Subject: Gastineau Channel 435, 2-920022. Summary of  
Environmental Reports on Occurrence, Concentrations and  
Leachability of Heavy Metals. Proposed Harbor Dredging  
at the Alaska-Juneau Gold Mine, North Rock Dump, Juneau,  
Alaska.

As the authorized agent for A.J. Associates, Inc., ASCG, Incorporated is responding to the written comments of three federal agencies which are reviewing this permit application.

**FIGURE 3**  
**SAMPLE LOCATION MAP**  
**ALASKA JUNEAU DUMP**  
**Juneau, AK**

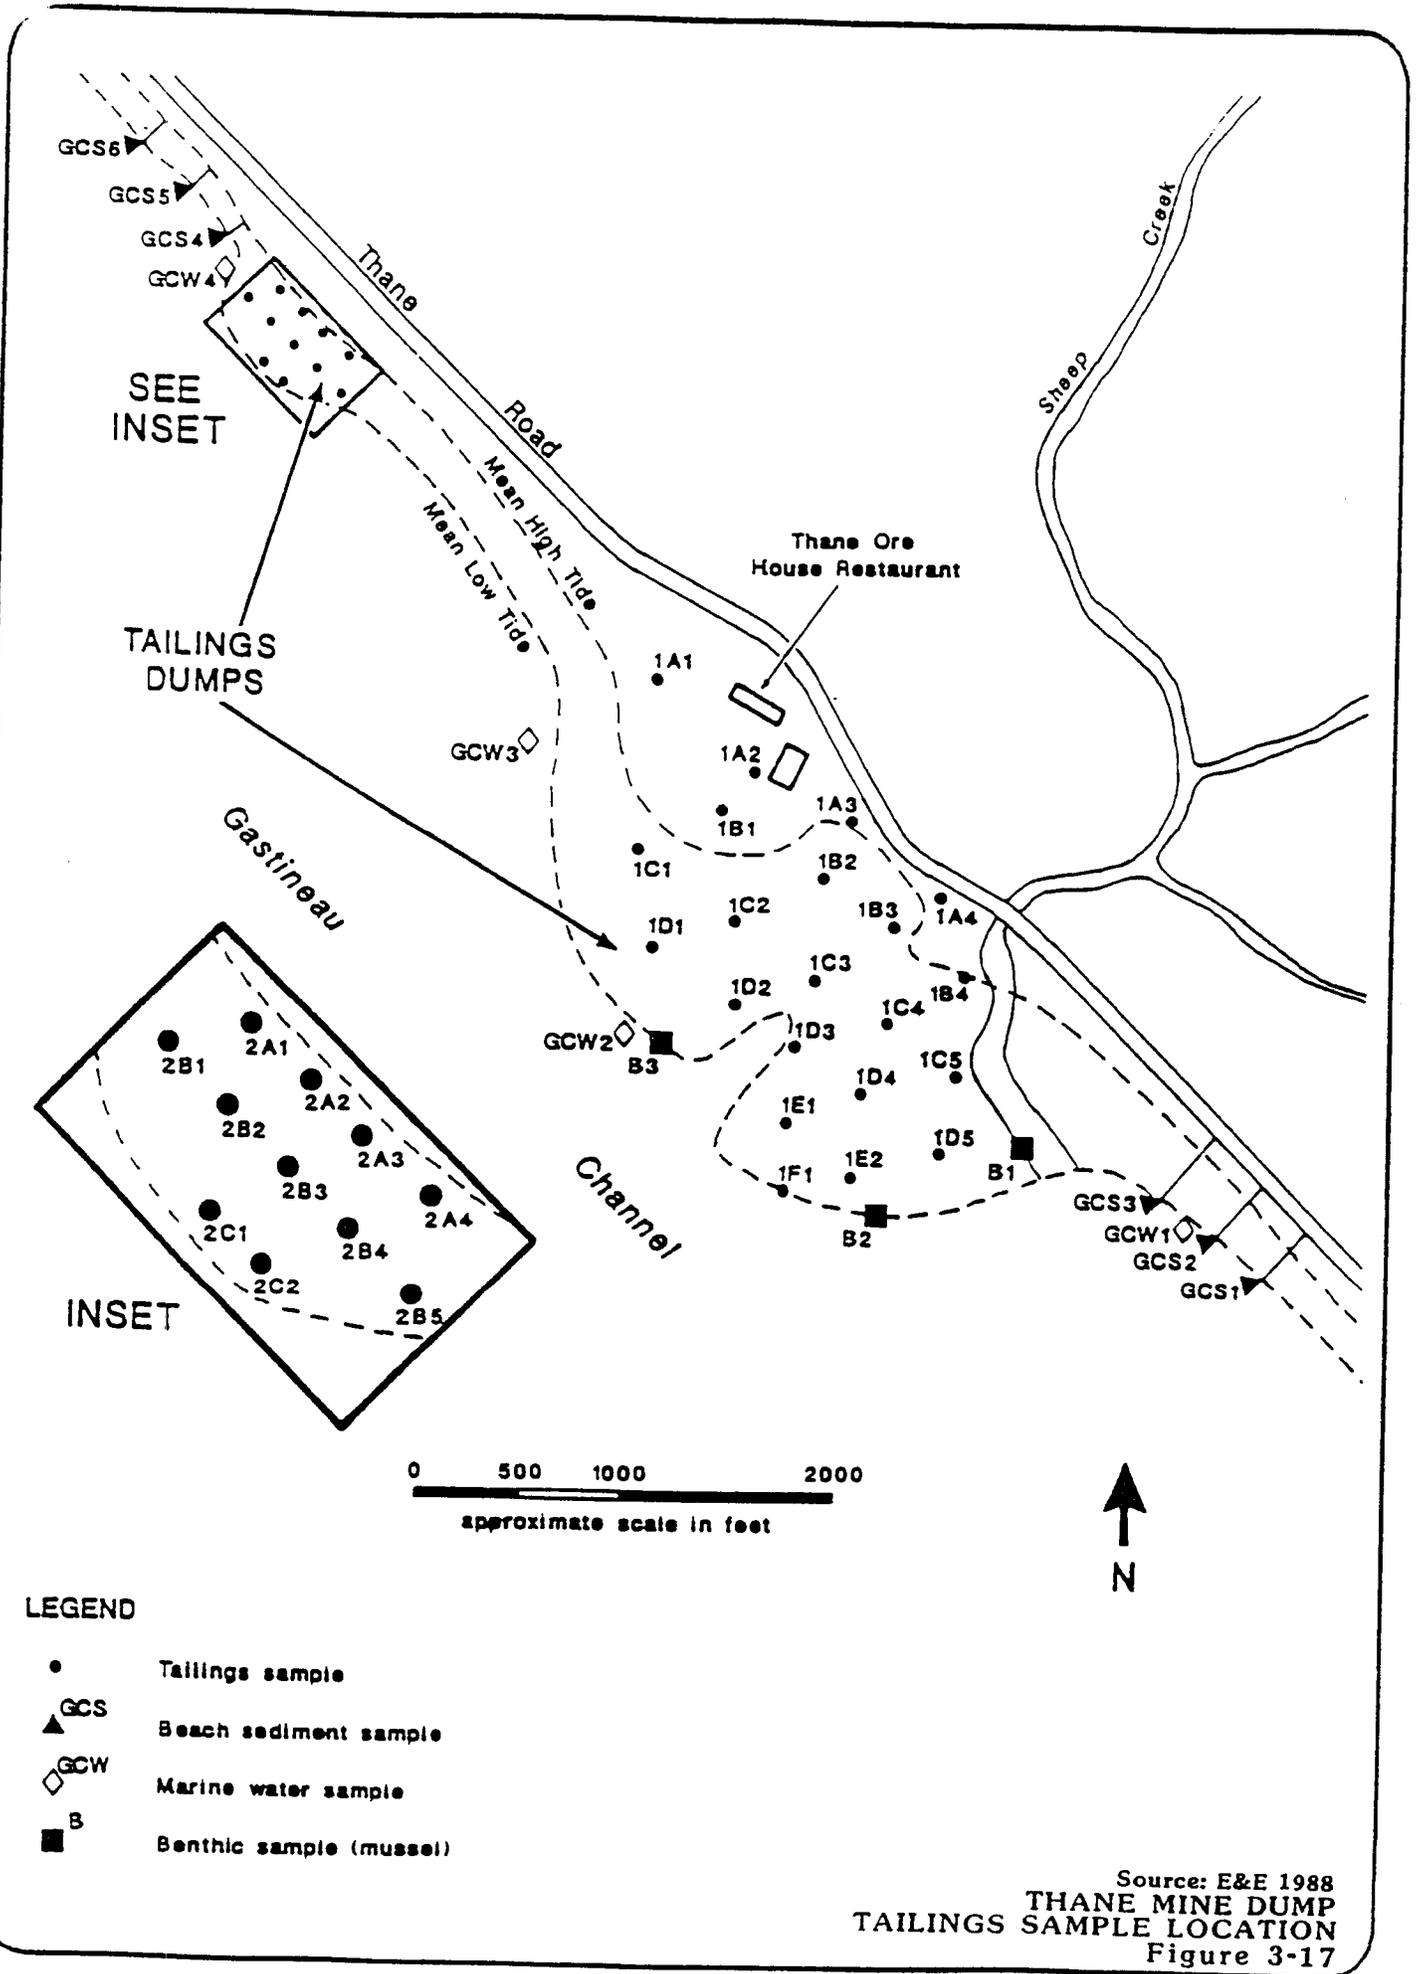
The U.S. Environmental Protection Agency (letter dated 3/23/92), National Marine Fisheries Service (letter dated 3/16/92) and the U.S. Fish and Wildlife Service (letter dated 3/18/92) have all expressed concern about the potential for the release of heavy metals resulting from the proposed dredge and fill project.

Ecology and Environment (1990) reported that on-site soil samples from the North Rock Dump had lead and zinc at elevated concentrations. The Ecology and Environment (1990) sample site #2 is located at the proposed dredging site for this project. None of the 1990 Ecology and Environment (E&E) samples were analyzed for leachability. However, the rock material from the Thane Rock Dump was derived from the same ore body as the North Rock Dump. Therefore, a comparison of the E&E (1988) samples and EP Tox results for the Thane Rock Dump allows for a reasonable extrapolation of the EP Tox values to the proposed dredging project location (see Tables 1 and 2, Figure 3, and Figure 3-17, Golder 1987, E&E 1990).

The EP Tox results for the Golder Associates (1987) North Rock Dump study are all within acceptable levels. In addition, a comparison of the E&E (1988) Thane Rock Dump samples and EP Tox results with the samples of E&E (1990) allows for a reasonable extrapolation of the acceptable EP Tox values of the Thane Rock Dump to the proposed dredging project location.

Adequate information exists from previous studies which demonstrates the proposed project will not result in the release of toxic substances in toxic amounts into waters of the United States. We therefore request that no further testing of the proposed dredge area be required.
